World Forum for Harmonization of Vehicle Regulations**Working Party on Lighting and Light-Signalling****Sixty-ninth session**

Regulation No. 10 (Electromagnetic compatibility)**Proposal for the 05 series of amendments to Regulation
No. 10 (Electromagnetic compatibility)****Submitted by the International Organization of Motor Vehicle
Manufacturers***

Figure 1

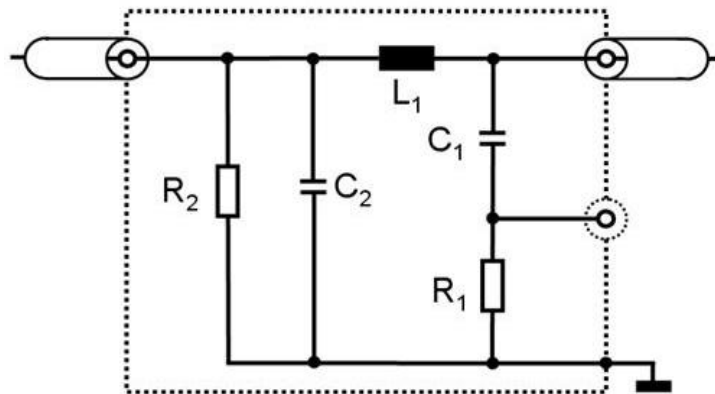
41. Appendix 8 (new): Definition of HV artificial network added.

Figure 3
Vehicle in configuration "REESS charging mode" coupled to the power grid

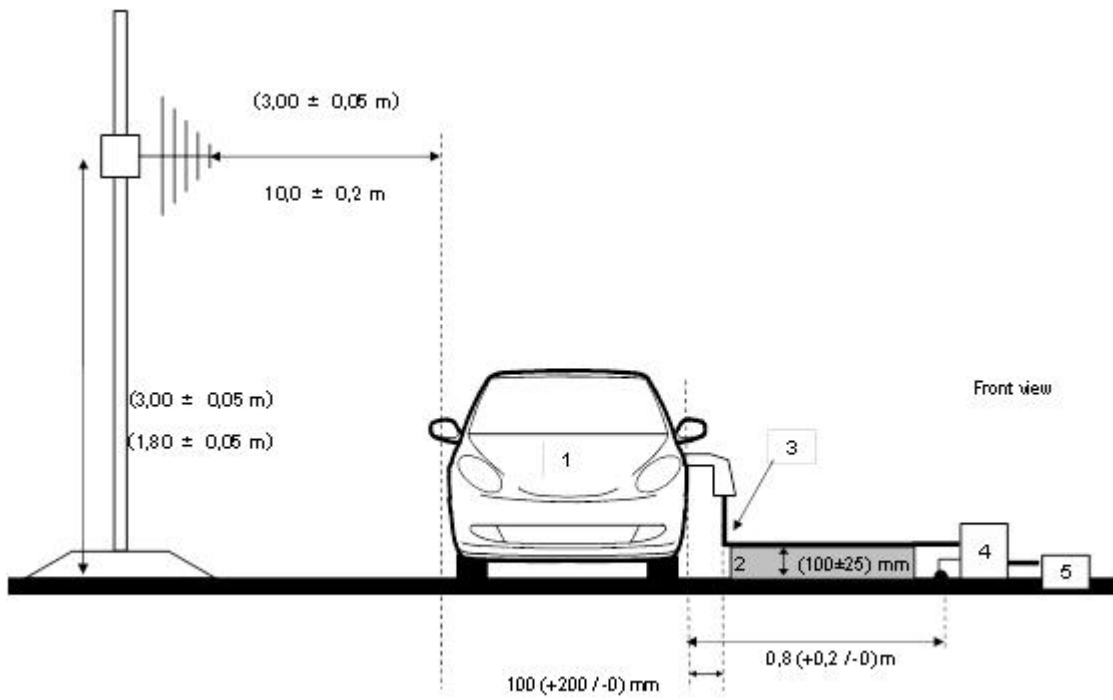
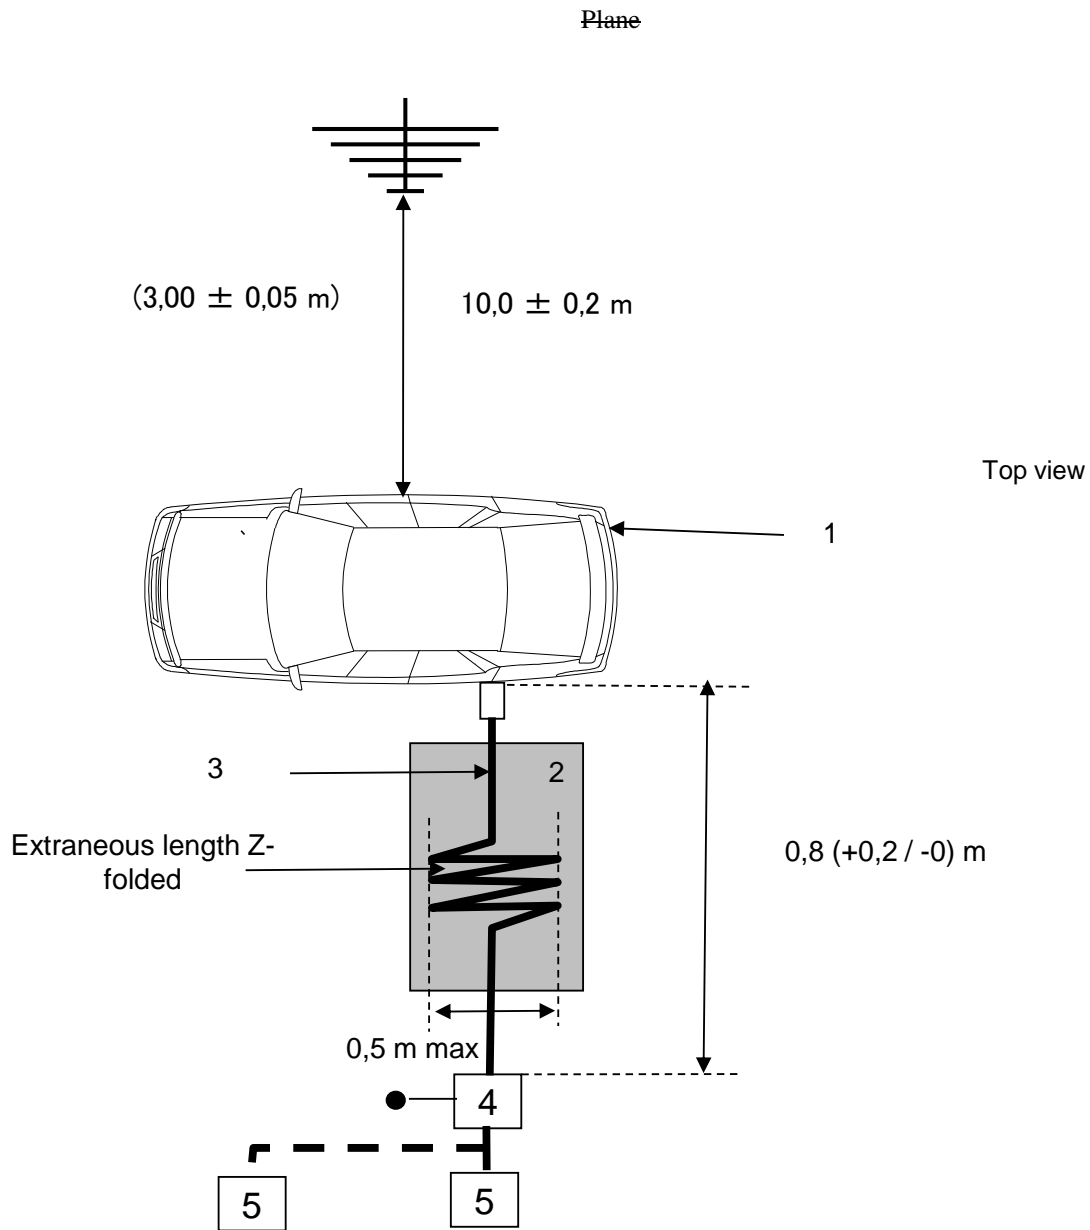
The test set-up for the connection of the vehicle in configuration **"REESS in charging mode coupled to the power grid"** is shown in Figure 3a to 3h (depending of AC or DC power charging mode, location of charging plug and charging with or without communication) of Appendix 1 to this annex.
 - 2.3. **Charging station / Power mains**

4.3. Tables 1 and 2 added to ensure correct adjustment of spectrum analyser- / receiver parameters.
 Appendix 1: pictures of test setup added, pictures including legends updated and more detailed.

Figure 4
Vehicle in configuration "REESS in charging mode coupled to the power grid"

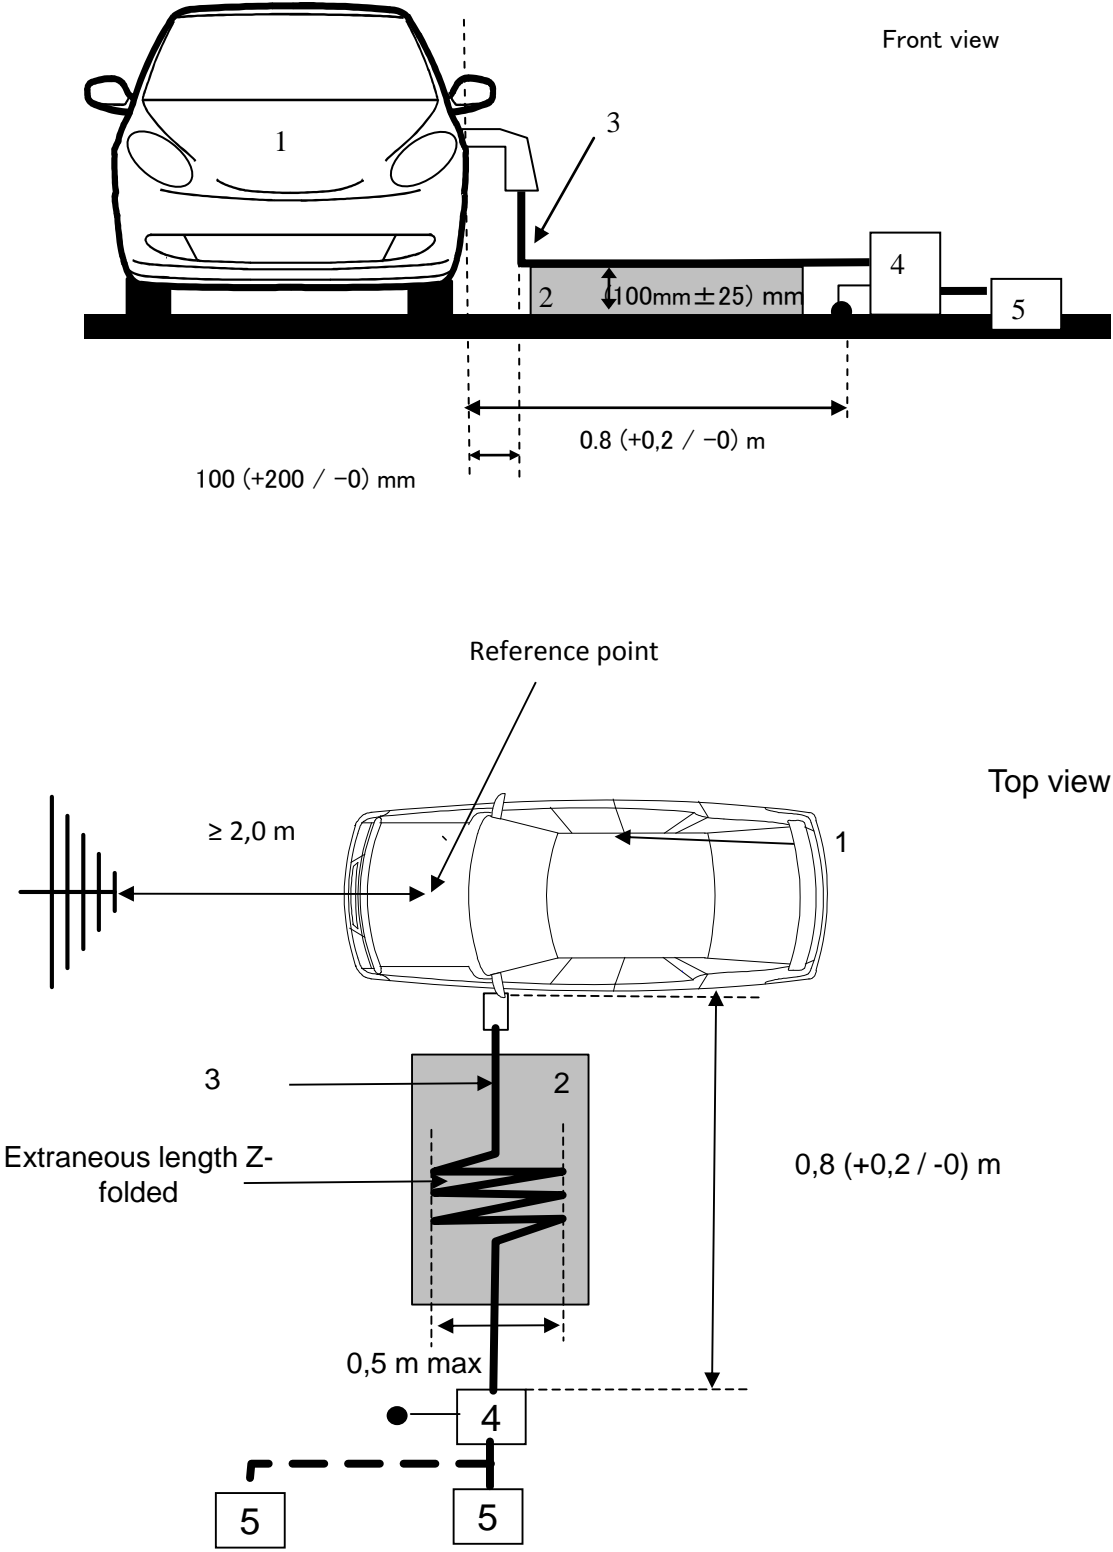
"2.2.3. The test set-up for the connection of the vehicle in configuration "REESS in charging mode coupled to the power grid" is shown in Figure 4a to 4h (depending of AC or DC power charging mode, location of charging plug and charging with or without communication) of Appendix 1 to this annex.

2.6. Placing of power charging / communication cable and setup
 Appendix 1: pictures of test set-up added, pictures including legends updated and more detailed.

Figure 1

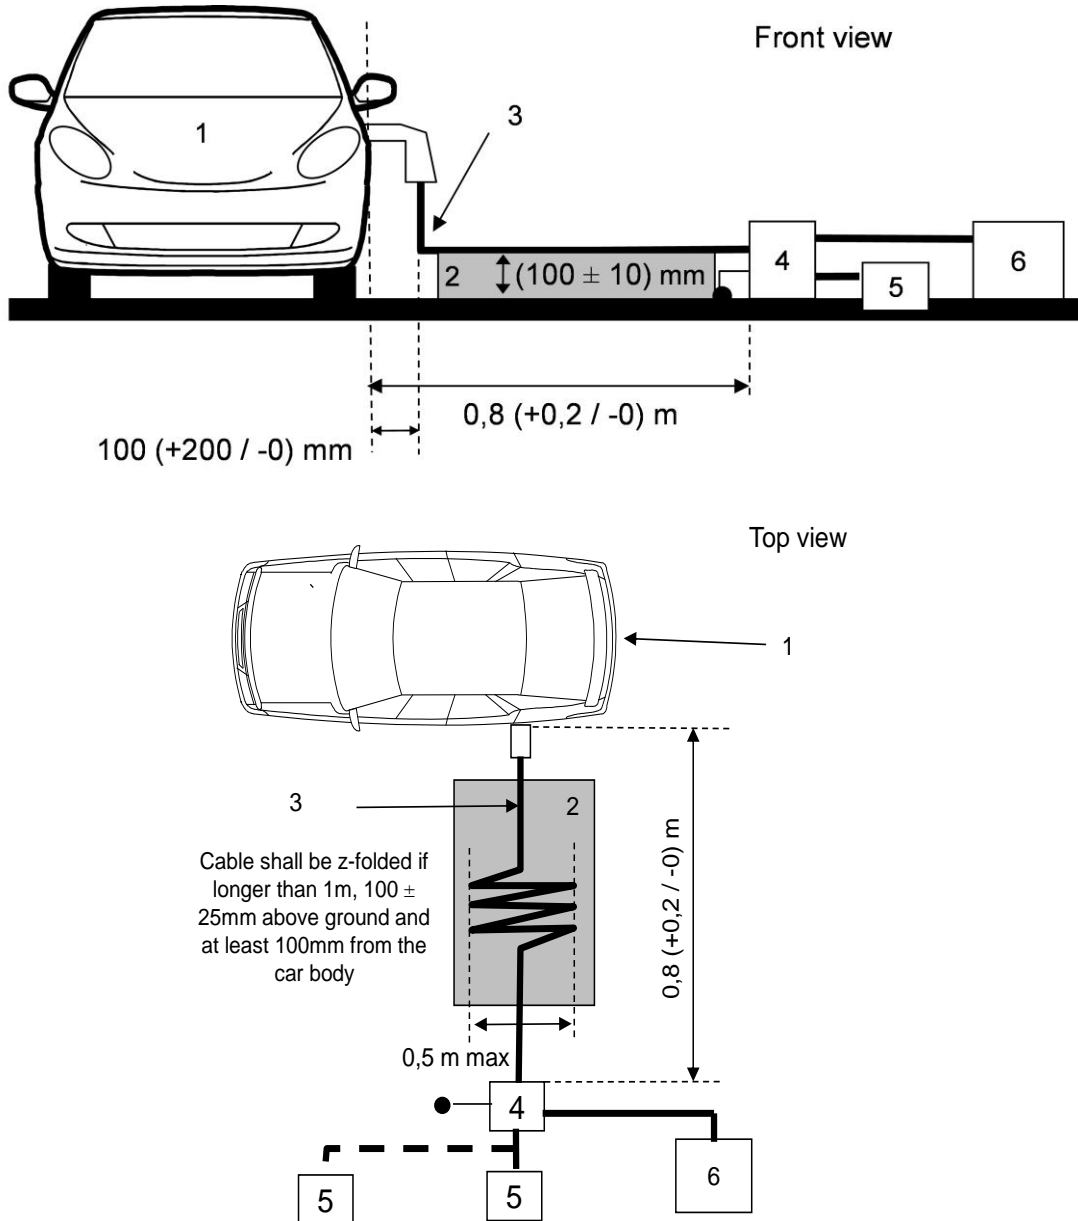
The AN shall be placed as defined in Figures 1a to 1d.
 - 3.3. The test set-up for the connection of the vehicle in configuration "**REESS** charging mode coupled to the power grid" is shown in figure 1 of Appendix 1 to this annex.

- 51. Annex 13:
 - 2.1. Definition of SOC of traction battery, current consumption and handling added.
 - 3.2. Definition of using artificial network.
- Appendix 1: pictures of test setup added, pictures including legends updated and more detailed.

Figure 1

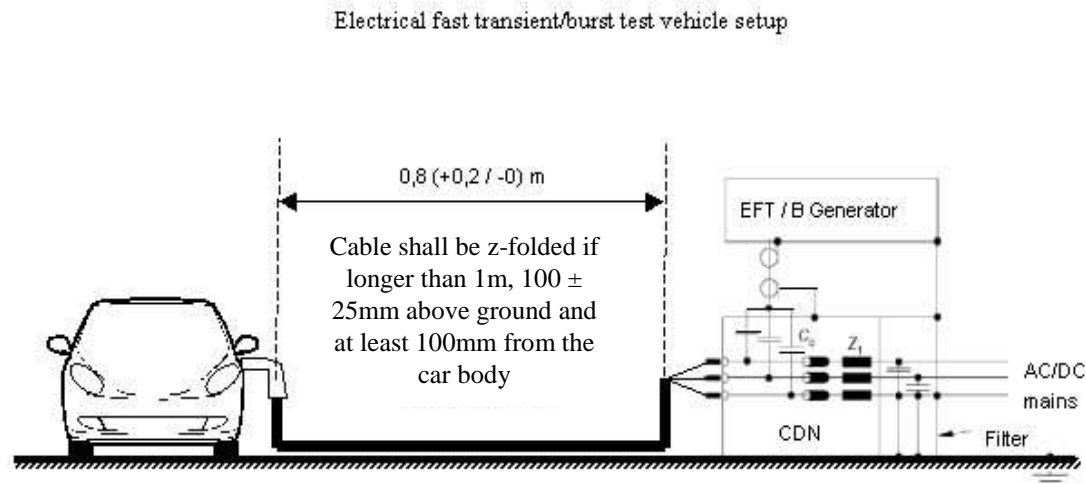
- 5.1.2. Test phase
- The vehicle shall be positioned on the ground plane. The electrical fast transient/burst (EFT/B) shall be applied on the vehicle on the AC/DC power lines in common modes by using CDN as described in Appendix 1, Figure 1 of this annex.

- 2.1.2. Definition of SOC of traction battery, current consumption and handling added.
- Appendix 1: picture updated with more details.

Figure 1

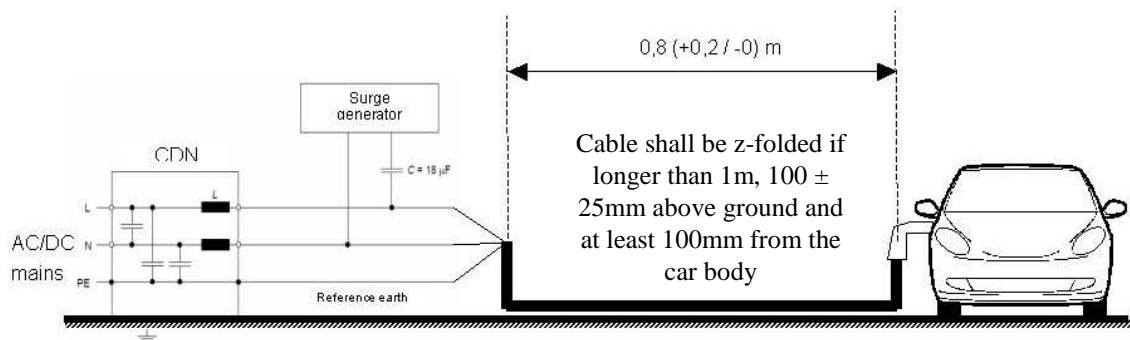
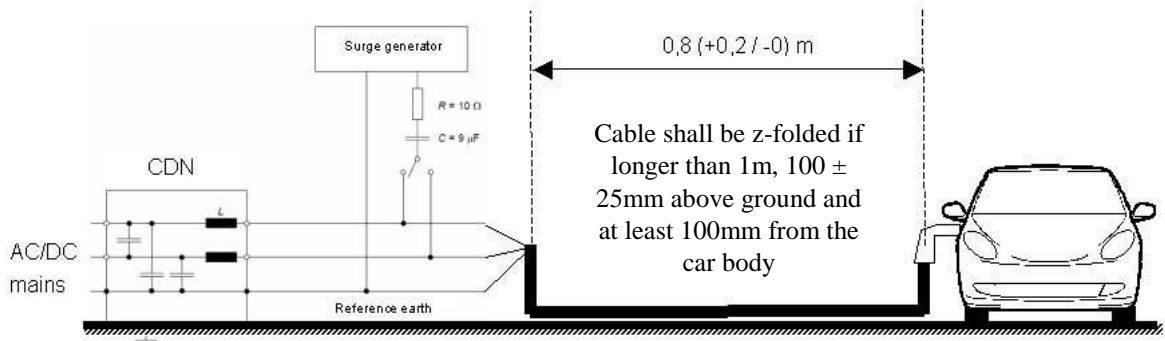
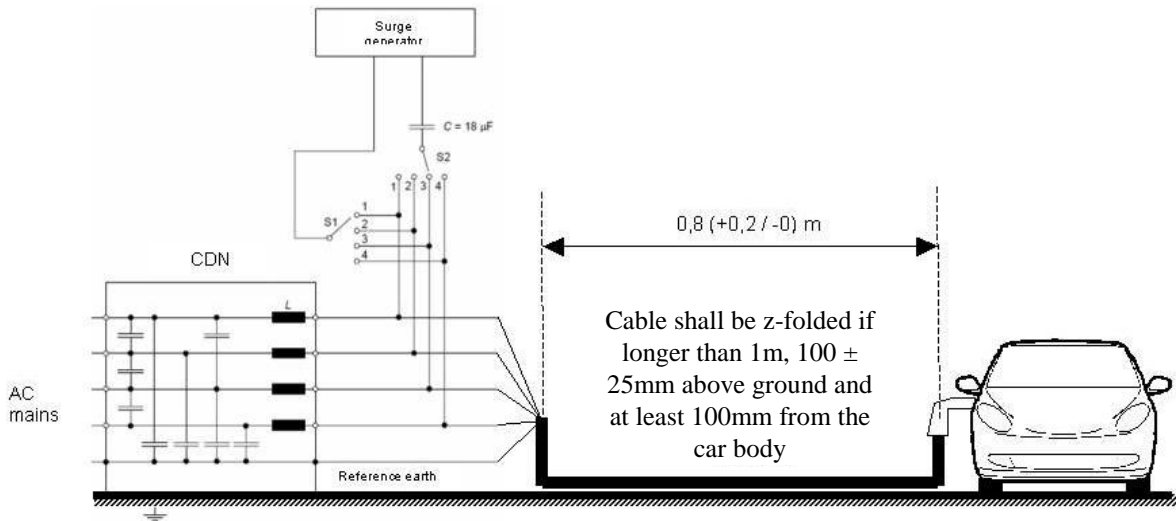
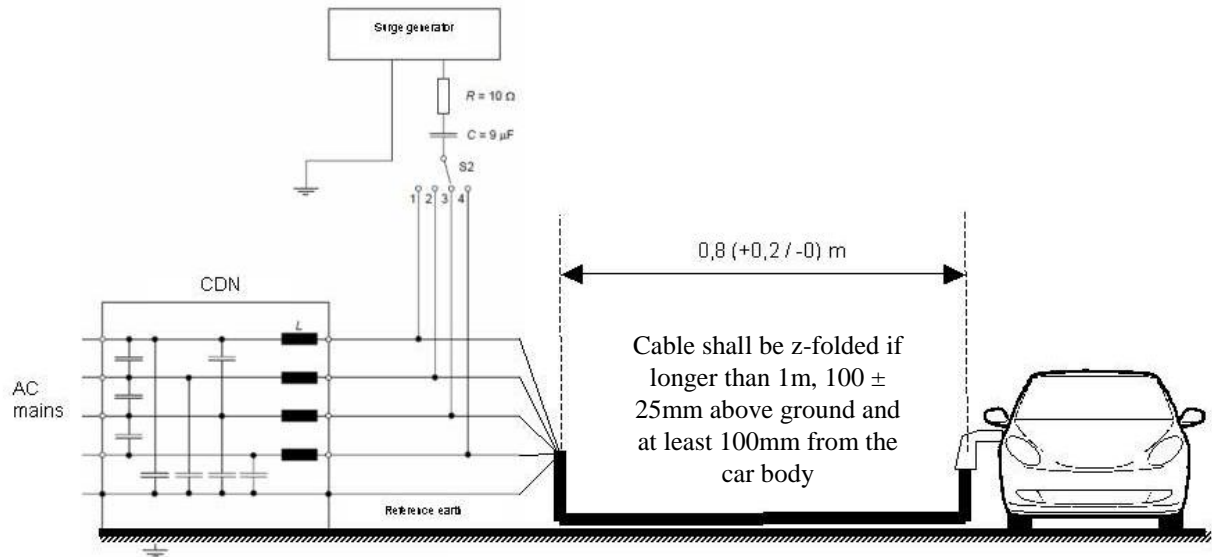
The vehicle shall be positioned on the ground plane. The electrical surge shall be applied on the vehicle on the AC/DC power lines between each line and earth and between lines by using CDN as described in Appendix 1, Figure 1 to 4 of this annex,

54. Annex 16:
2.1.2. Definition of SOC of traction battery, current consumption and handling added.
Appendix 1: pictures updated with more details.
55. Annex 17 (complete new ESA test method defined): Emission of harmonics generated on AC Power lines from an ESA.
